Meeting: 10/18/2023
Applicant: Alma Johnson
Owner: Alma Johnson

Location: 3220 Orlando St. **Parcel ID** 70 P A 051
Zoning: RN-2 (Single-Family Residential Neighborhood)
District: Edgewood Park Infill Housing Overlay District

Level II Additions Visible from the Primary Street, Changes to Porches Visible from the Primary Street

10-A-23-IH

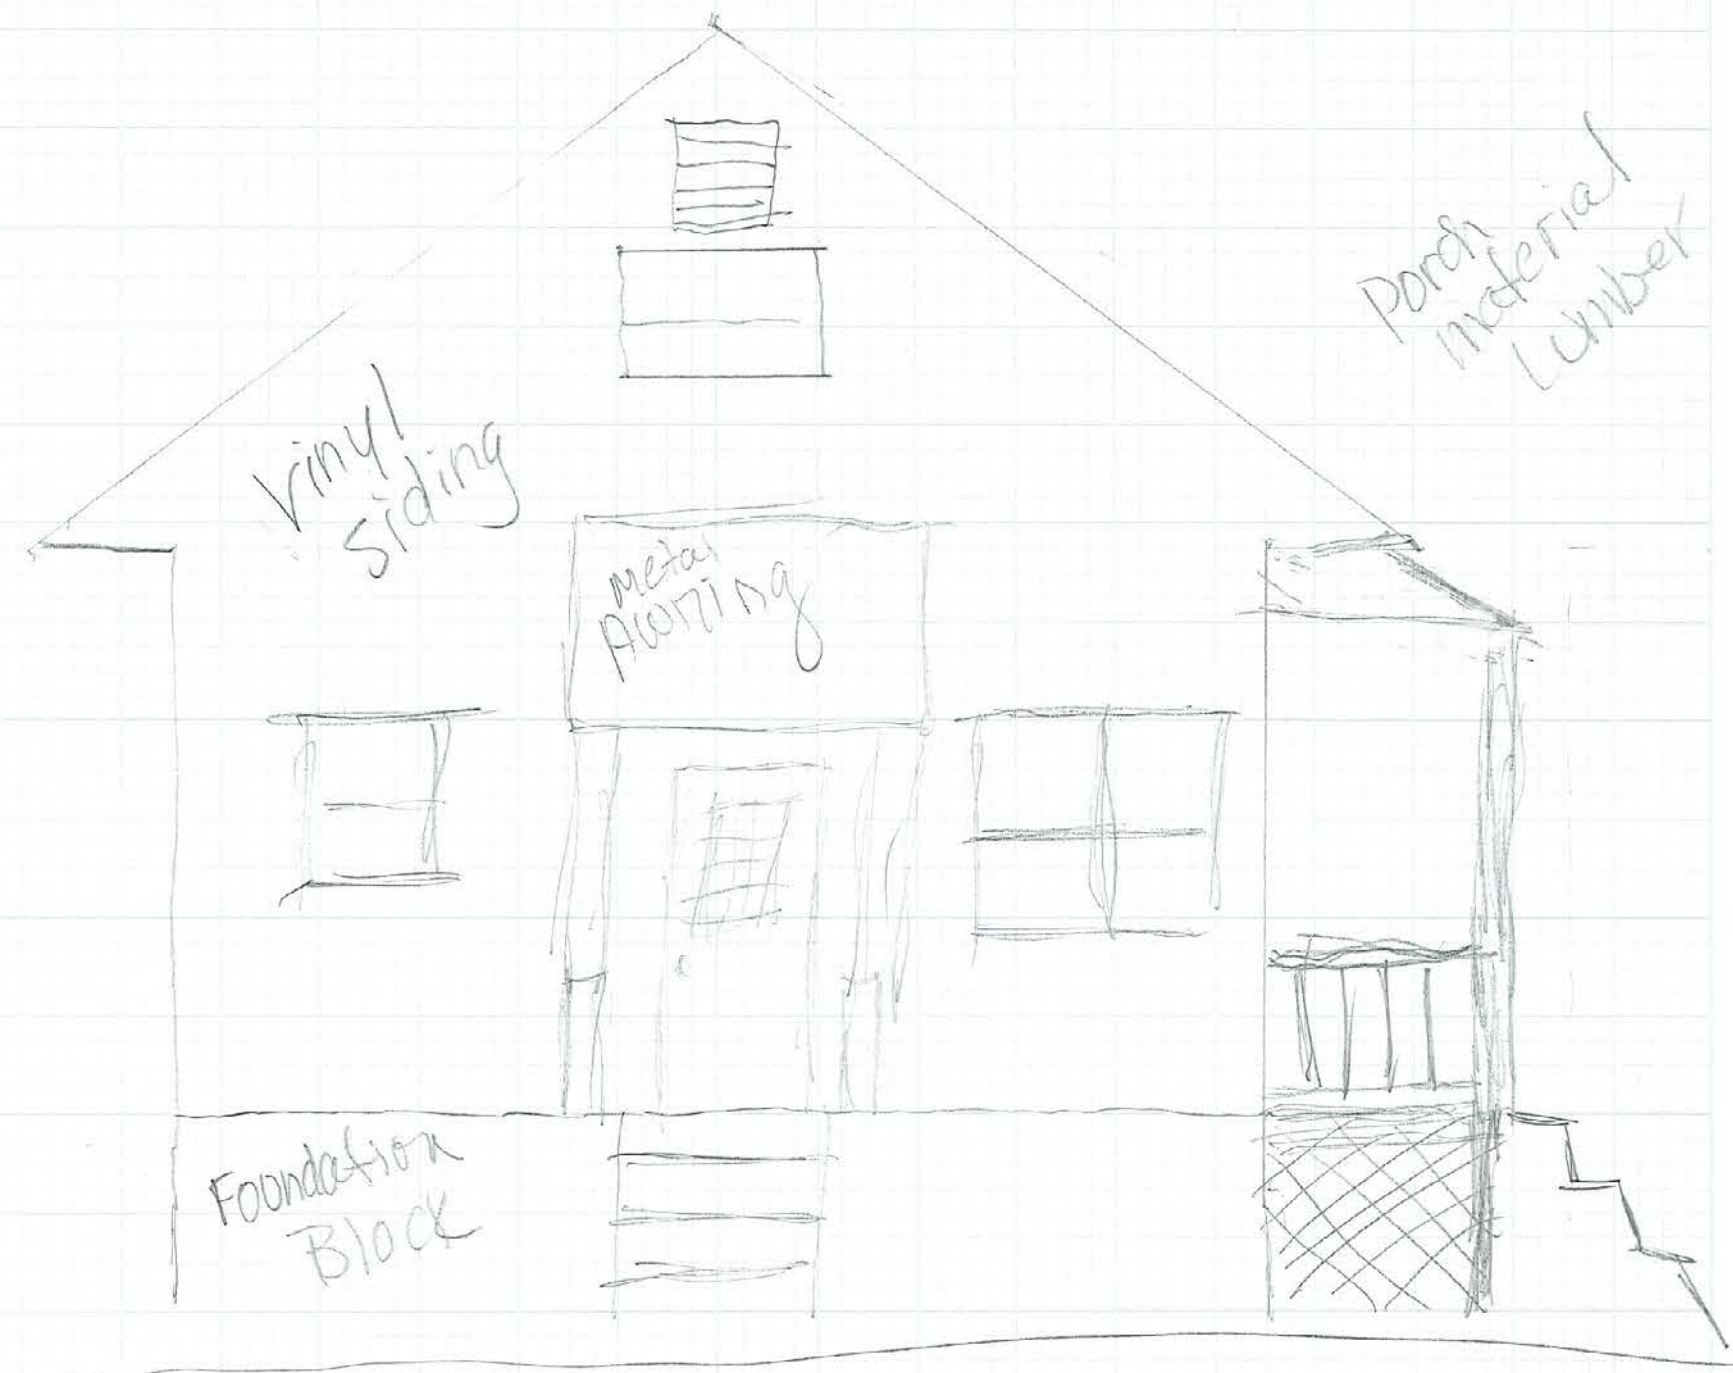
3. A metal roof and square wood posts meet the design guidelines. The posts should be increased to 6 by 6 square posts to be proportional to the house. Additional information on the railing should be submitted to staff for approval.

Staff recommends approval of Certificate 10-A-23-IH, subject to the following condition: 1) select 6 by 6 wood posts instead of the proposed 4 by 4s.
